UPDATE
Project #15-034
Maverick – 1000 West 200 North
Located at the northwest corner of 1000 West and 200 North

<i>Project Name:</i>	Maverick Store – 1000 West
<i>Proponent / Owner:</i>	Todd Meyers / Raymond Family Properties LC
<i>Project Address:</i>	1000 West 200 North
<i>Request:</i>	Design Review Permit
<i>Current Zoning:</i>	Commercial (COM)
<i>Type of Action:</i>	Quasi-Judicial
<i>Hearing Date</i>	July 23, 2015 – continuation to September 10, 2015
<i>Submitted By:</i>	Amber Reeder, Planner II

SHEET TITLE
PRELIMINARY LANDSCAPE

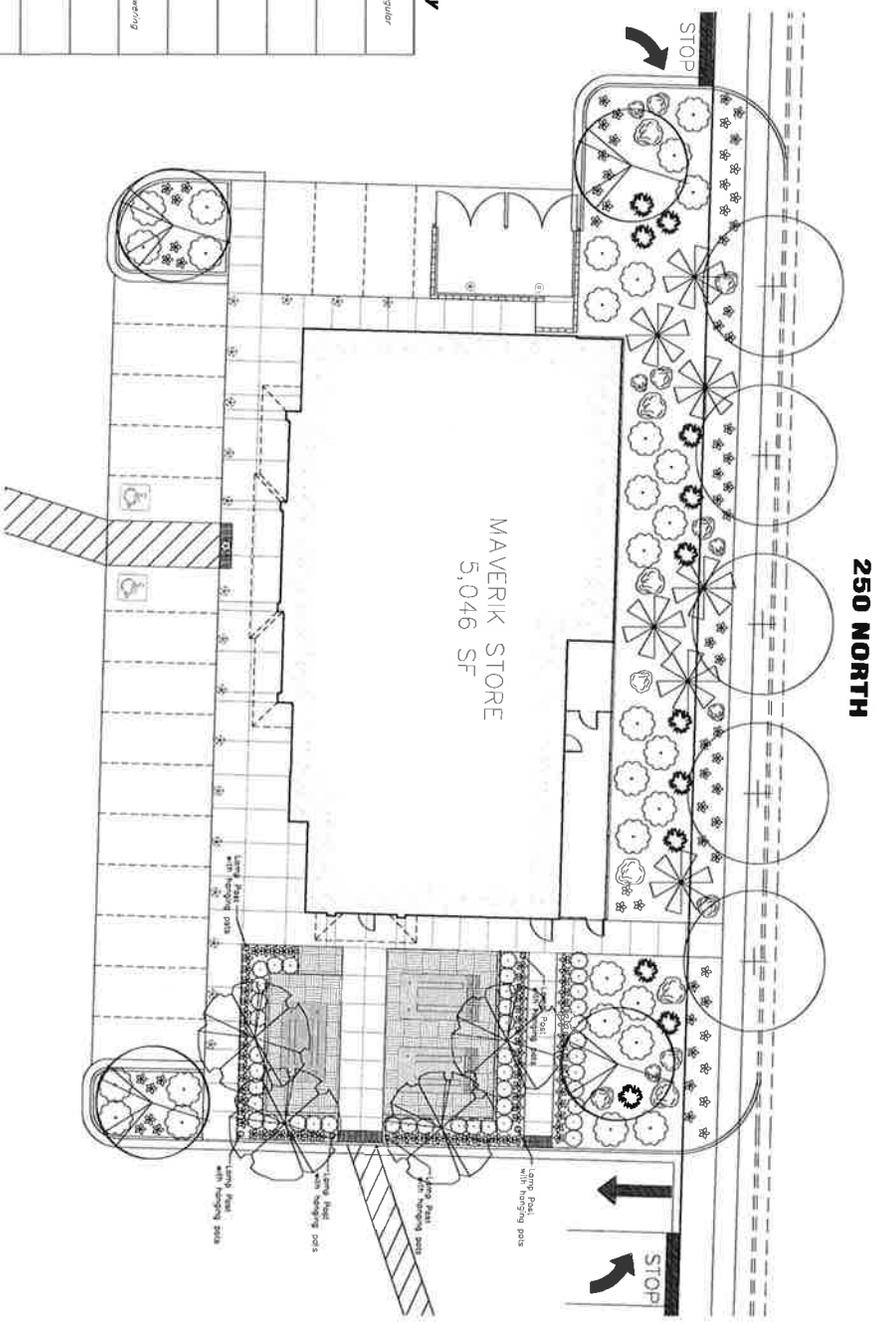
The north elevation has been modified to include a spandrel glass, column features, and cornice features. A conceptual landscape plan has been provided which indicates additional trees and shrubs between the building and the right-of-way. The interior functionality does not allow for view windows on this elevation, the spandrel glass covers 34% of the elevation. This elevation is in compliance with building form requirements.

3. The site layout is found to be compatible with the area and unique constraints of the site.
4. A performance landscaping plan, prepared in accordance with §17.39 of the LDC, shall be submitted for approval to the Community Development Department prior to the issuance of the building permit. The plan shall include the following:

- a) Street trees along all adjacent streets provided every thirty (30) feet on center in parkstrip or property adjacent to the sidewalk where sidewalk is adjacent to the roadway.

- b) Open Space and Useable Outdoor areas shall total a minimum of 27,942 SF.
 - c) A total number 64 trees and a minimum of 5 varieties of species shall be provided. A minimum total of 161 shrubs, perennials and grasses shall be provided.

- d) A minimum of 25% of the required plant material will be evergreen varieties.
 - e) Parking lot landscaping adjacent to 1000 West and parking areas of 250 North will meet the Type "B" guidelines of LDC§17.39.070.B.2. and §17.39.070.C for Parking Lot Interior Landscaping.

RENDERED FRONT ELEVATION

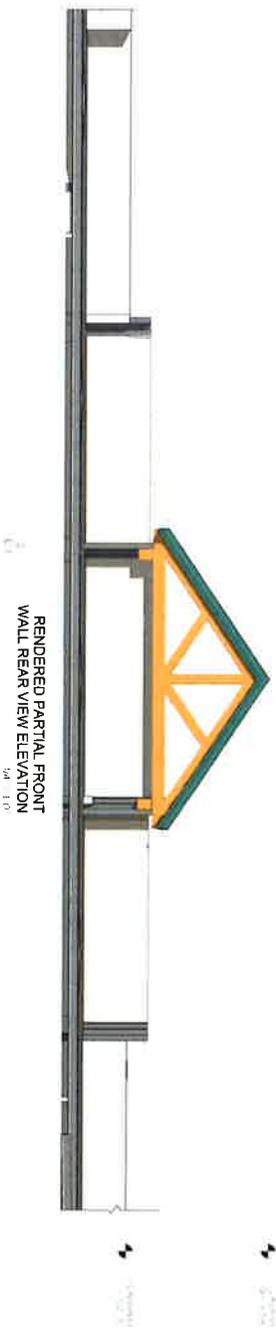
Updated Elevations have been provided for the north, east, and west facades. The Planning Commission recommended at project continuation that additional glass be added around the door on the east elevation. The updated rendering indicates the additional windows around the door, which emphasizes the entrance. The east elevation was previously at 3% transparency and the glass doubles that to 6%. The wall does include a large gable feature around the door and, if considered, takes up 30% of the wall. There is also a set of trellis gazebos adjacent to this side of the building that sit between the building and view from 1000 North. The gazebos, landscaping, and lighting also make this building elevation more appealing. The gable structure and consideration for the additional adjacent features can be found to bring this elevation into compliance.

RENDERED REAR ELEVATION

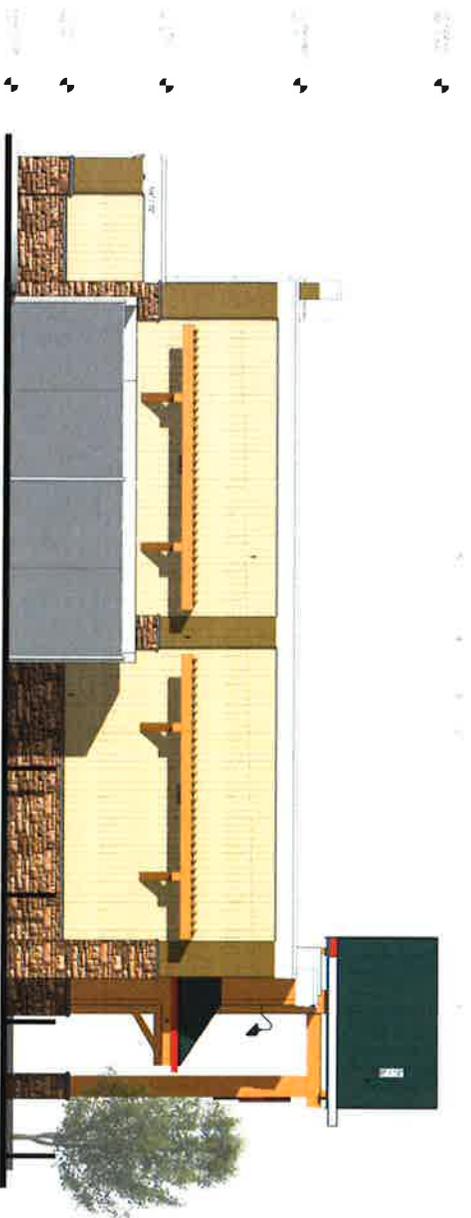
The LDC 17.19.070 indicates that blank walls exceeding 30 linear feet are prohibited. Acceptable breaks include windows, balconies, wall articulation or changes in color or material. With the color and material changes along with columns and articulation, the project meets the blank wall requirements in the LDC.
